# **Zebra SERVICE BULLETIN**

Service Bulletin #101 Page 1 of 2

**Date:** August 27, 1999

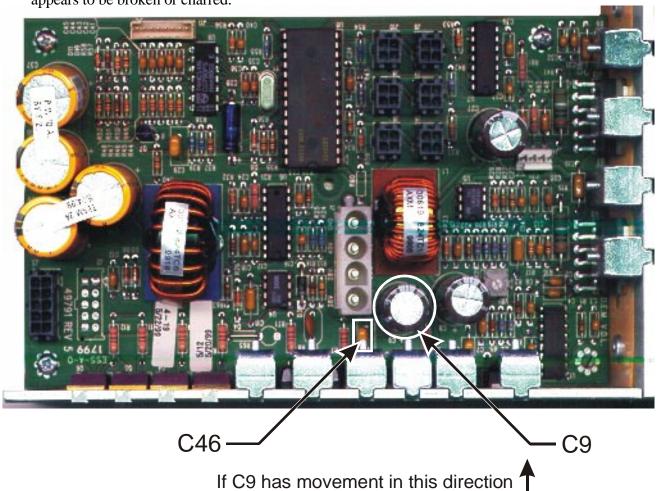
- 1. Turn the printer off and remove the power cord from the printer.
- 2. Access the electronic compartment of the printer by removing the electronics cover.
- 3. Locate the DC power supply module (refer to the printer maintenance manual for location).
- 4. Locate capacitor C9 as shown in the diagram. If C9 was reworked or replaced, there will be visible red mark on top of the capacitor.

5. To determine if C9 is defective, lightly move C9 up and down relative to the picture below. If the capacitor exhibits movement, replace the DC Power Supply. Also check to see if C46 appears to be broken or charred.

If C9 has movement in this direction (relative to this picture)

if C46 appears broken or charred, the DC Power Supply is defective

If a loose component (C9) is identified, Zebra recommends replacing the DC power supply module to correct this issue. Zebra does not recommend component level rework of the DC power supply module.
